Progress Report
Second Quarter 2008 – April 1 to June 30
Midwest Roadside Safety Facility
Midwest State's Regional Pooled Fund Program
June 20, 2008

Pooled Fund Consulting Summary

Midwest Roadside Safety Facility
April 2008– June 2008

Figure 2. Nine Foot Post Detail

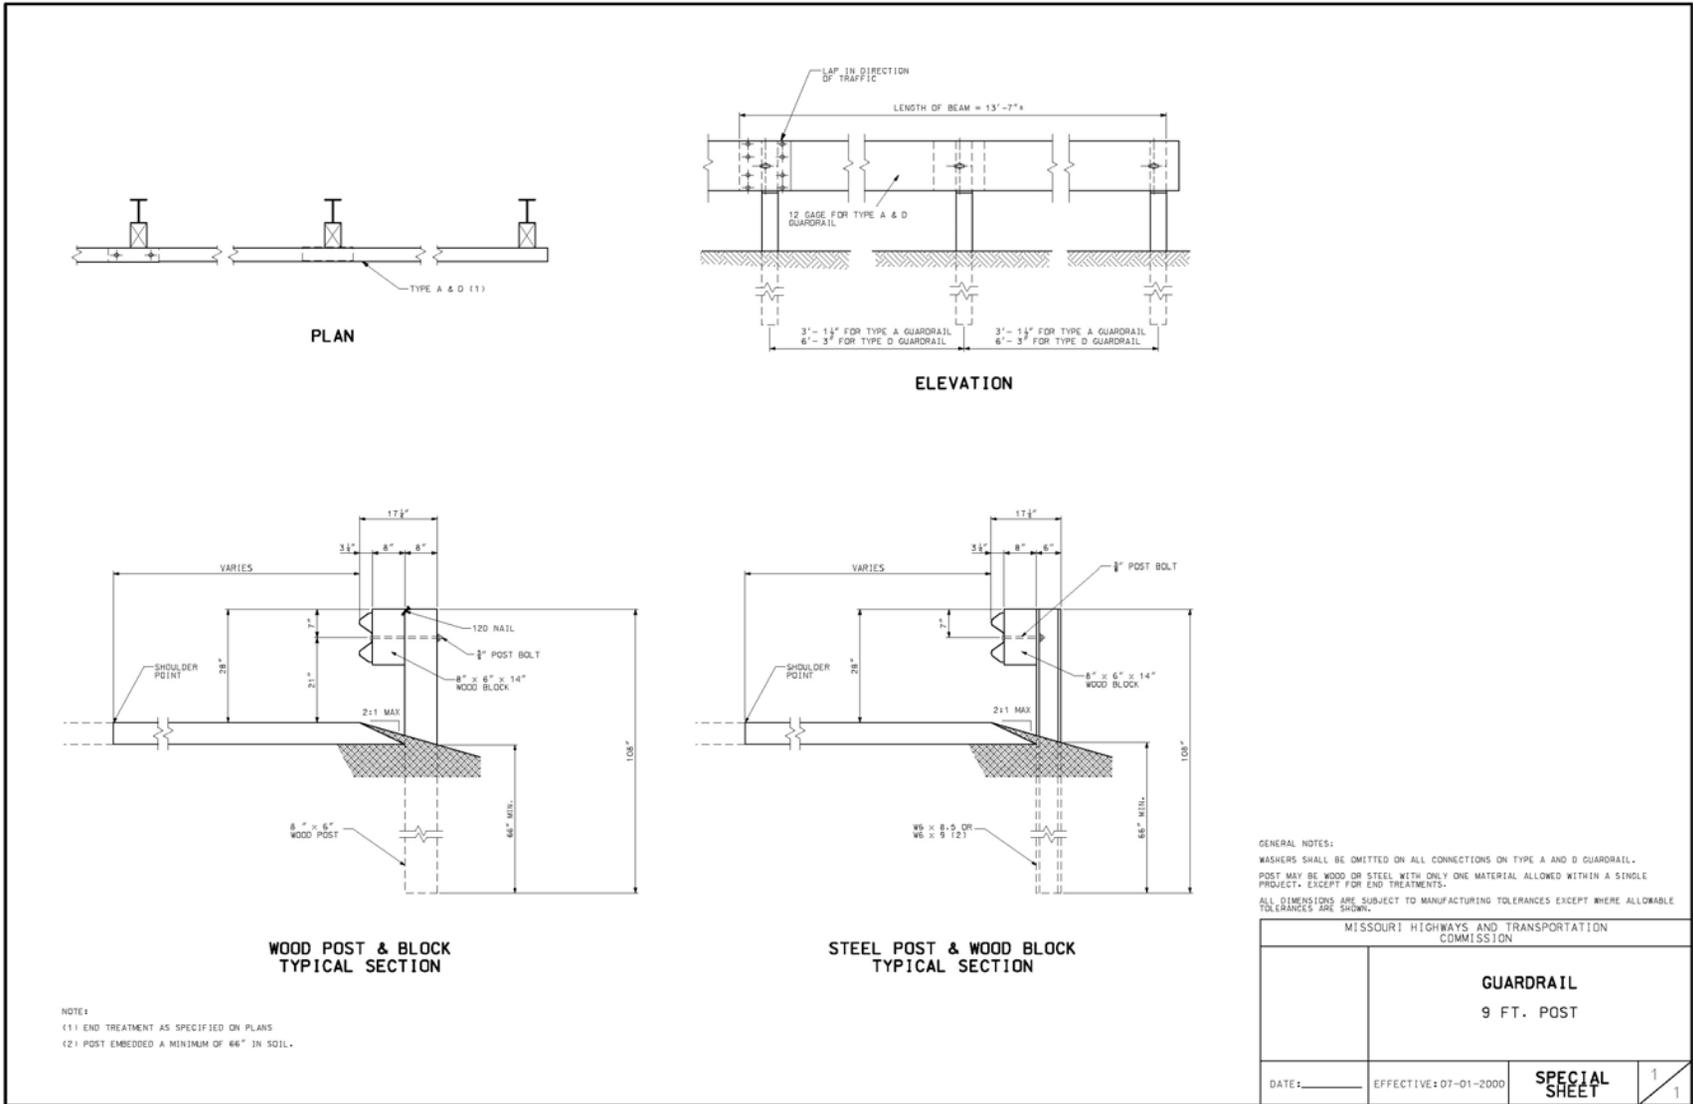
We have a situation as shown below. Please provide guidance or a recommendation regarding the W Beam Guardrail Wood post spacing and length of posts. This situation did not fall into the categories as stated on pages 28 and 29 of the recent Pooled Fund Quarterly Report.

I looked at your schematic of the w-beam guardrail installation on what appears to be a 3:1 slope with a 1:1 or a 2:1 slope behind it. Missouri had a similar issue in the past. We recommended to them that they use 9' posts at ½ post spacing (3'-1 ½"). I have attached the detail they made based on this recommendation.

We would recommend a similar post length and spacing for your installation.

I looked at the energy of the TL-2 impact, and I believe that you can use 7' long post at ½ post spacing in this installation for TL-2. That should help you out quite a bit.
